ZIONSVILLE PLAN COMMISSION MEETING RESULTS

Tuesday, February 18, 2020

Docket Number	Name	Address of Project	Item to be Considered
2019-52-Z	HUB I-65 Phase Two	4255 S. 300 East	<p>Received a Favorable Recommendation to the Town Council 4 in Favor 1 Opposed 2 Recused</p> <p>Petition for Zone Map change to rezone approximately 81.369 acres from the (AG) Agricultural Zoning District to the Rural (I1) Light Industry Zoning District.</p>

Docket Number	Name	Address of Project	Item to be Considered
2020-04-CA	Appaloosa Crossing	10901 E. 300 South	<p>Continued to the March 16, 2020 Plan Commission Meeting 7 in Favor 0 Opposed</p> <p>Petition for a Commitment Amendment of 57.53± acres to amend the location of a water feature along U.S. 421 from the midpoint of the overall development's frontage to the southern portion of the frontage along U.S. 421.</p>
2020-01-PP	Appaloosa Crossing	10901 E. 300 South	<p>Continued to the March 16, 2020 Plan Commission Meeting 7 in Favor 0 Opposed</p> <p>Petition for a Primary Plat of 57.53± acres for 12 lots, 2 blocks, and 4 common areas within the Rural (GB) General Business Zoning District, the Rural (PB) Professional Business District, and the (R-2) Lo

Exhibit 8

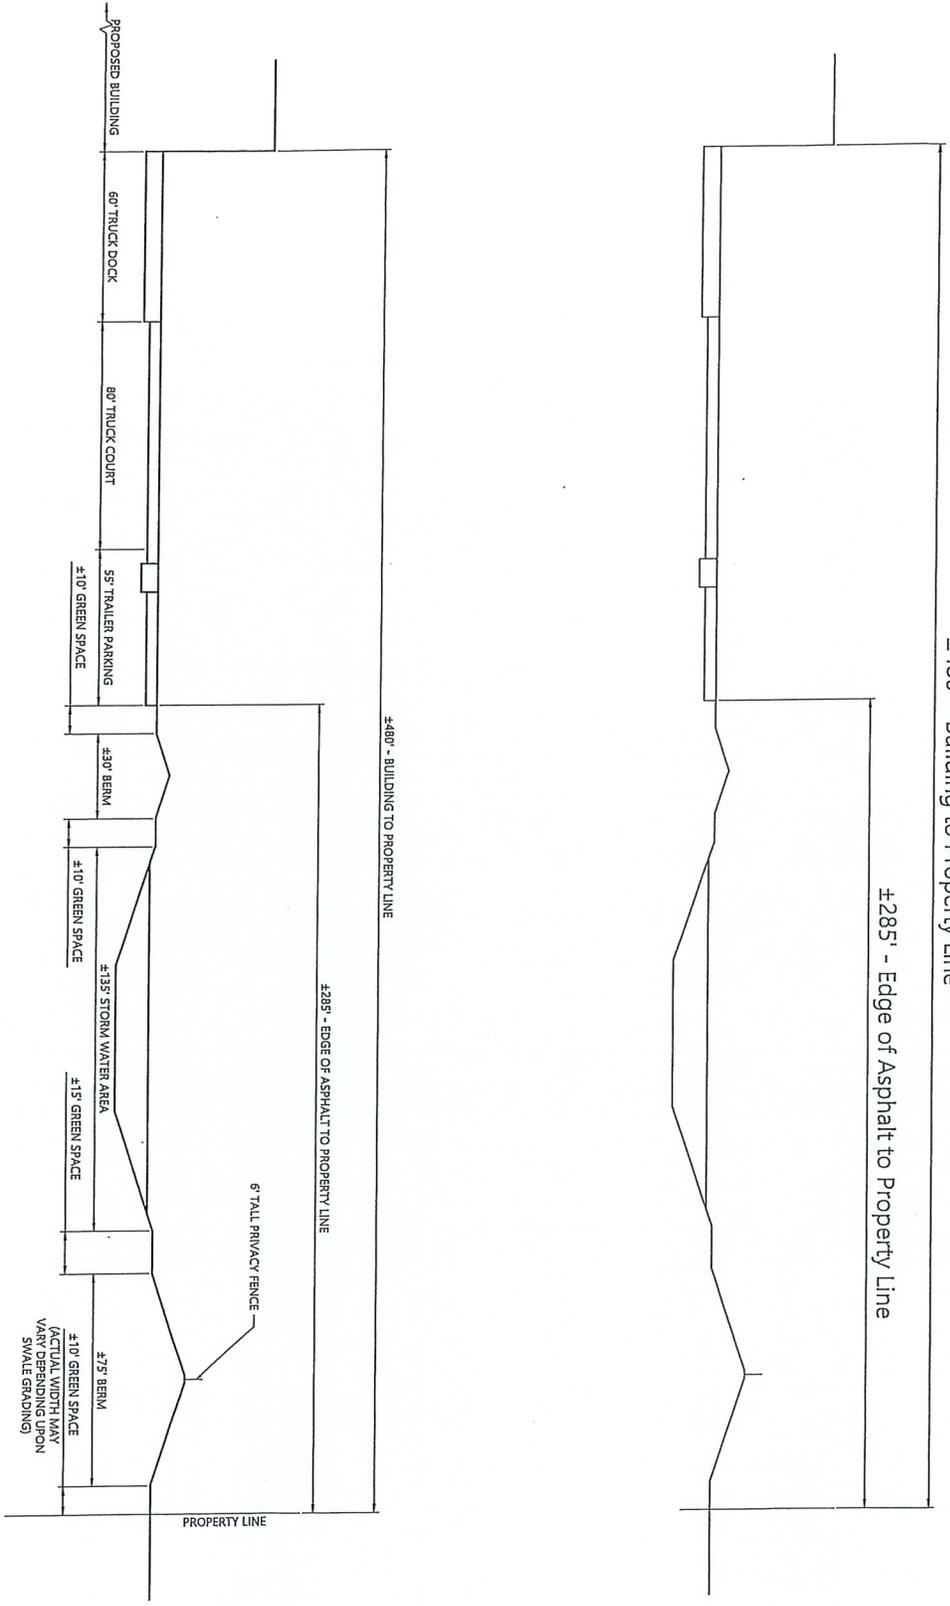
- i) The cross-section exhibit does not show or contain the safety ledge required 6 inches below the proposed normal pool per pages 10 and 11 of the Town's Stormwater Standards. The safety ledge affects pond area storage, which can affect pond size and the footprint of the overall pond, which can in turn affect other elements and dimensions of the site plan. Pending other considerations, such as pass-through and on-site drainage, this item could affect the overall area and size of the development.

Exhibit 9

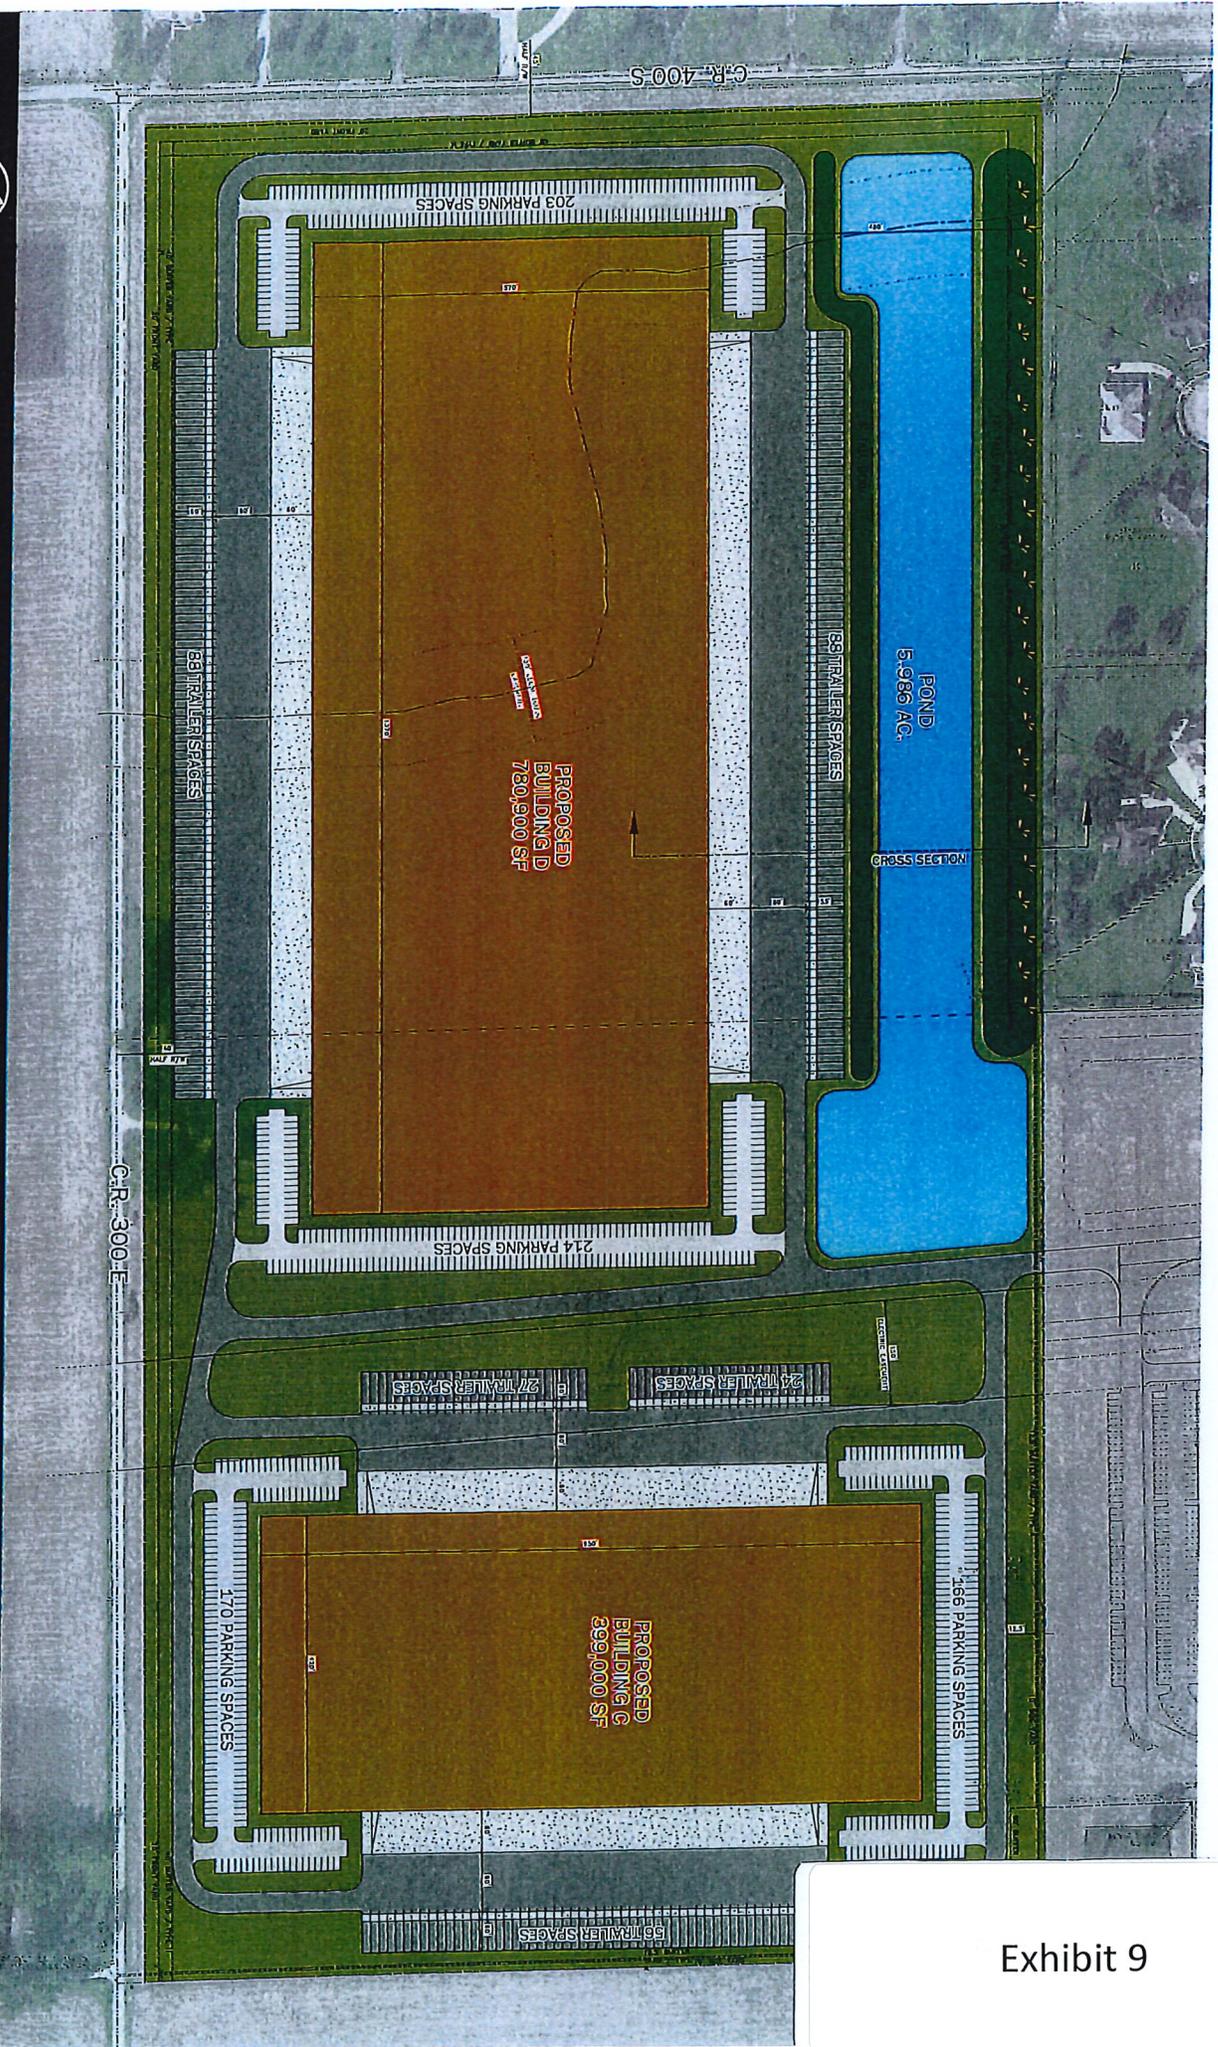
3. Commitment number 8 references the site plan and states bufferyards. I recommend editing that statement to read: "The development of real estate shall comply with the bufferyard requirements for Rural development standards and process outlined in the Town's Zoning Code." The email we just received states the bufferyards won't be a part of the zoning petition, but the commitments presented in the package references the site plan and specifically references bufferyards.

SITE DEVELOPMENT PLAN
SHEET: 6 OF 42

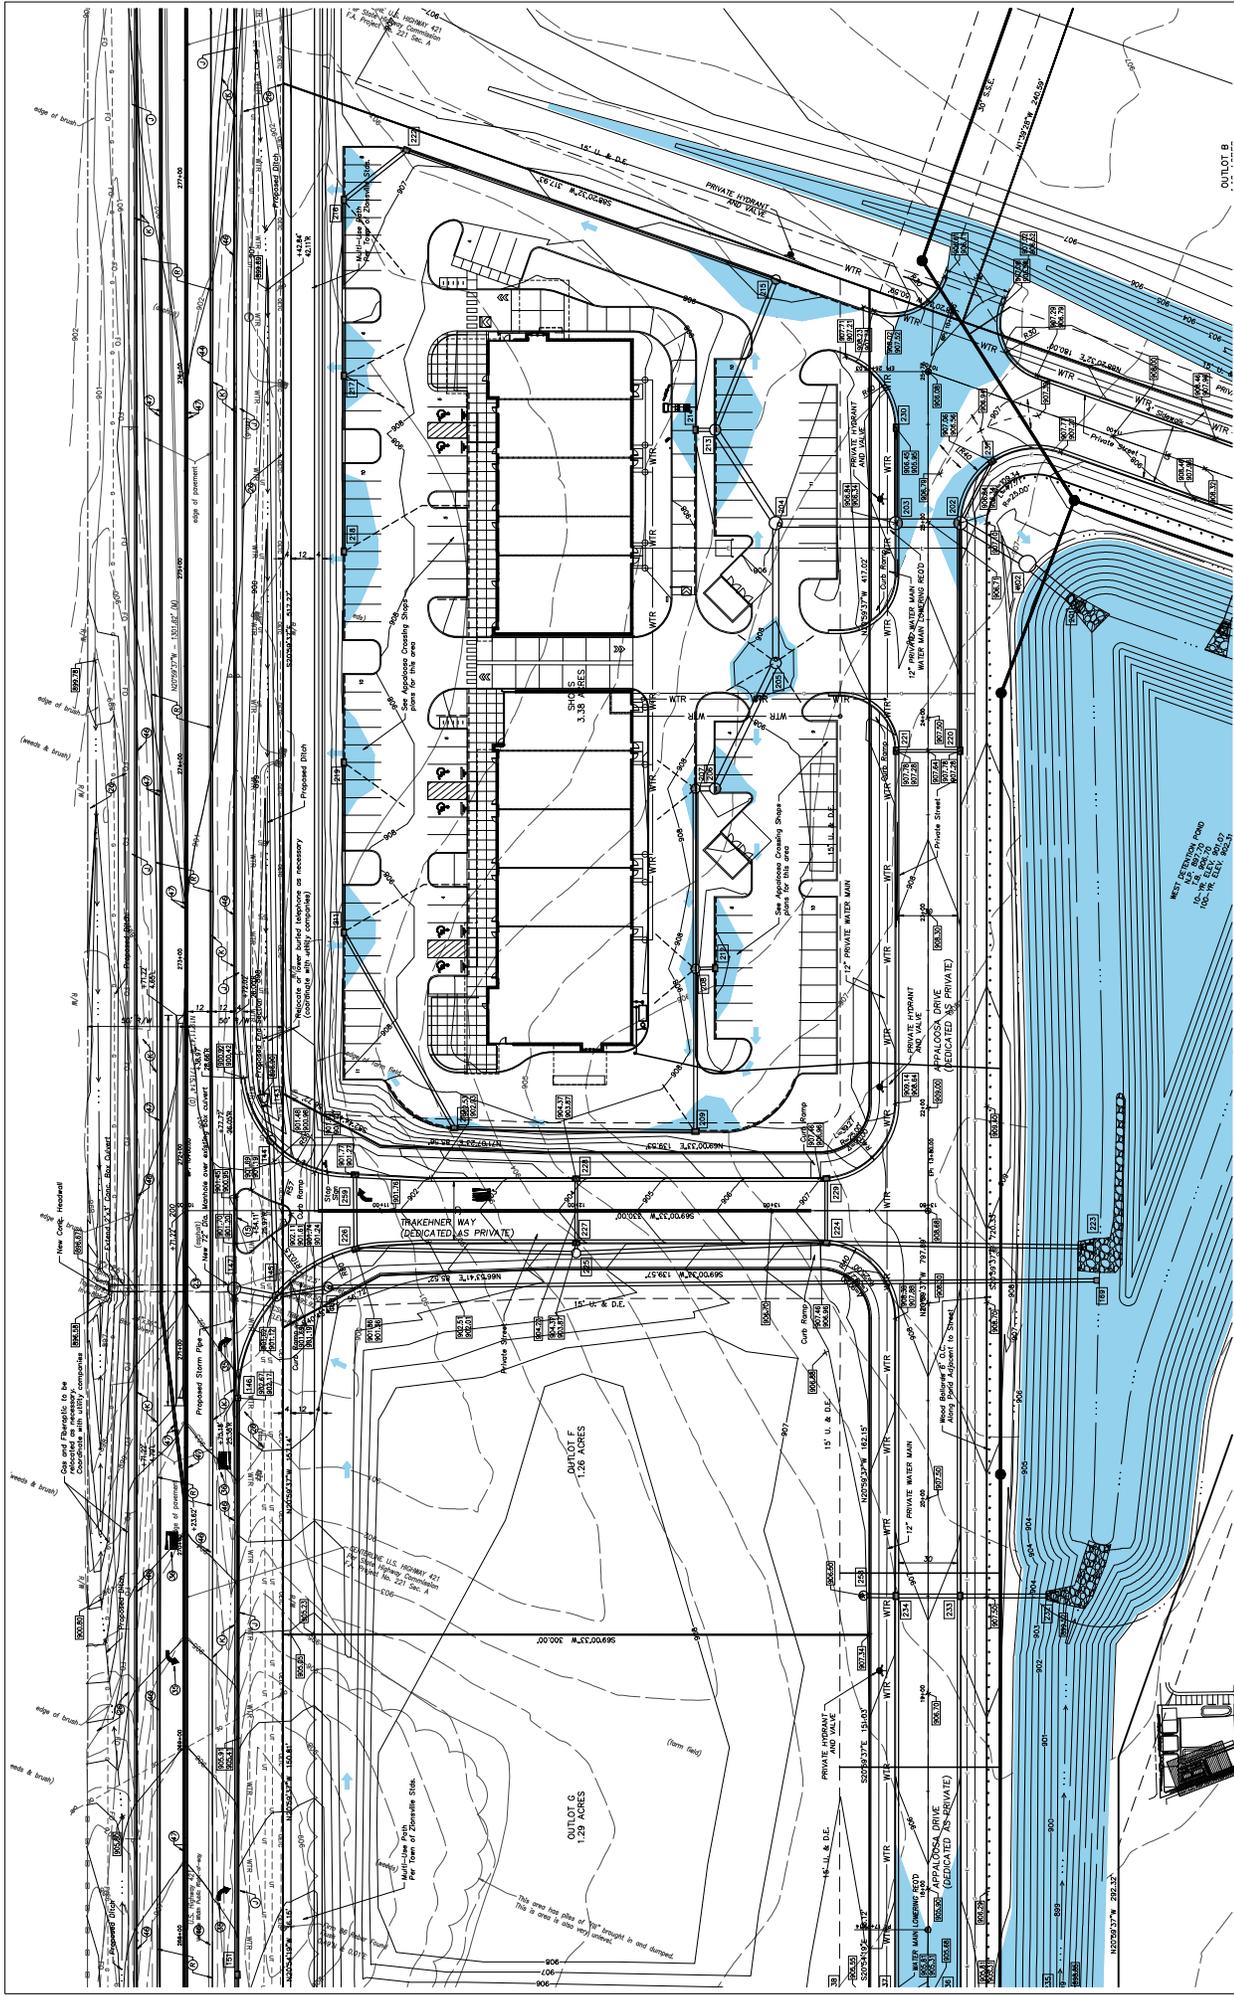
II. Offsite contours on Sheet 6 of the overall site development plans are not sufficiently labeled to determine and assess topography.

II. Offsite contours on Sheet 6 of the overall site development plans are not sufficiently labeled to determine and assess topography.
